# Comhairle Chontae Atha Cliath Theas

## Record of Executive Business and Chief Executive's Order

**Reg. Reference:** SD21A/0159      **Application Date:** 17-Jun-2021  
**Submission Type:** Clarification of      **Registration Date:** 15-Dec-2021  
Additional  
Information

**Proposed Development:** Land recontouring/infilling works on c.16,000sq.m.  
of a folio size of c.2.4ha (allowing buffers); volume  
of material to be placed on site is c.35,000m<sup>3</sup> with an  
average fill level of c.3.5m above existing.

**Fig. 1: Scanned extract from Figure 6 of Site-Specific Flood Risk Assessment, Appendix 3 of applicant's FI Response Report of 21<sup>st</sup> October 2021.**

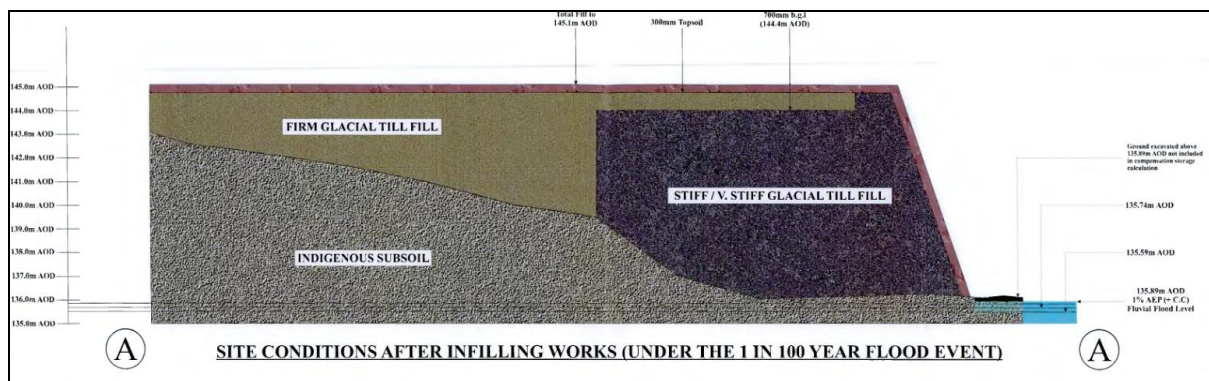
- (2) Environmental Services and Water Pollution have each signalled their acceptance of the report. It should be noted however that another drawing (Figure 6, Flood Risk Assessment) shows a much steeper slope at the site's edge. This drawing should be revised or accurate, authoritative, site sections provided by way of **clarification of additional information**. The Planning Authority is intent on ensuring that no polluting or destructive slippage of materials in the River Camac can occur as a result of this development, and notes the potential for increased extreme weather events in the very near future due to the effects of climate change.

- 1.1** Water Services have concerns regarding the steep side slopes of infill area proposed in close proximity to the Camac River. Figure 6 within the submitted Site Specific Flood Risk Assessment shows a wall of infill material approximately 9m in height in close proximity to the River which would be susceptible to collapse during/after a period of rainfall. The applicant is required to demonstrate how the proposed infill area will not collapse, allowing infill material to pollute the Camac River to the south. Terracing of material and

South Dublin County Council has concerns regarding the steep side slopes of infill area proposed in close proximity to the Camac River. Figure 6 within the submitted Site Specific Flood Risk Assessment shows a wall of infill material approximately 9m in height in close proximity to the River which would be susceptible to collapse during/after a period of rainfall. It is noted that this conflicts with the Geotechnical Engineer report provided. The Planning Authority is intent on ensuring that no polluting or destructive slippage of materials in the River Camac can occur as a result of this development, and notes the potential for increased extreme weather events in the very near future due to the effects of climate change.

The basis for CFI item 2 was the inclusion of a drawing in the applicant's Flood Risk Assessment which showed an infill area of 9m above the river Camac, with a very steep slope down to the bank. A total height of 9m would be contrary to the Geotechnical Stability Report (which recommends no more than 7m and assesses on that basis) and the planning notices (which mention an average fill above surface level of 3.5 metres). See figures below.

- (a) provide an accurate and authoritative set of layouts and site sections showing the slope on the site to adhere to that described in the Geotechnical Engineering report. The drawings shall include slope gradients of the infill area and the interface with the River to the south.
- (b) submit a drawing in plan view showing the distance from proposed infill area to the top of the river bank to the south along the length of the river bank.
- (c) to demonstrate how catastrophic mud flow and land slide can be prevented following periods of exceptionally heavy rain.

**Fig. 2: Scanned extract from “Stability Check for Filling of Hinch’s Field”, Appendix 2 of Applicant’s FI Response Report of 21<sup>st</sup> October 2021.**

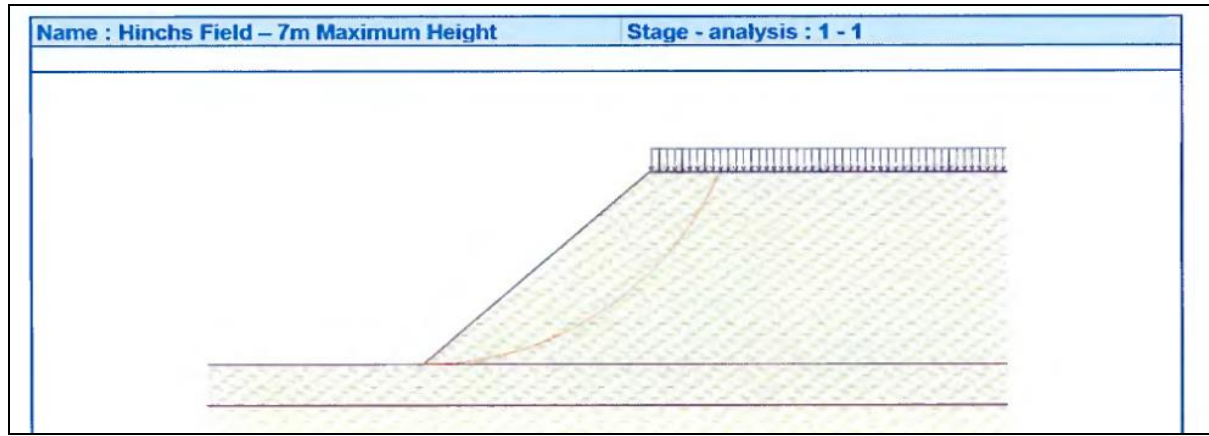
- Excavation slope not to exceed 40 degrees
- Long term surcharge loading to top of embankment not to exceed 5kPa

It may be the case that the use of stiff filling material at the edges of the infill area would mitigate against and prevent potential landslides into the river, either by itself or in combination with the separation distances of approx. 10m minimum between the base of the infill and the top of the river bank. The applicant has however failed to show, either by additional commentary from their geotechnical consultant, or by specifying the gradient of the slopes at the edge of the infill area, that the infill proposal would be safe and would not be subject to possible sliding during heavy rain events. It is paramount that the Planning Authority can be satisfied on this point prior to a grant of permission. If this is not resolved, then the material could cause a mud slide after heavy rain and / or block the stream leading to a build up of water which may give rise to a catastrophic mud slide.
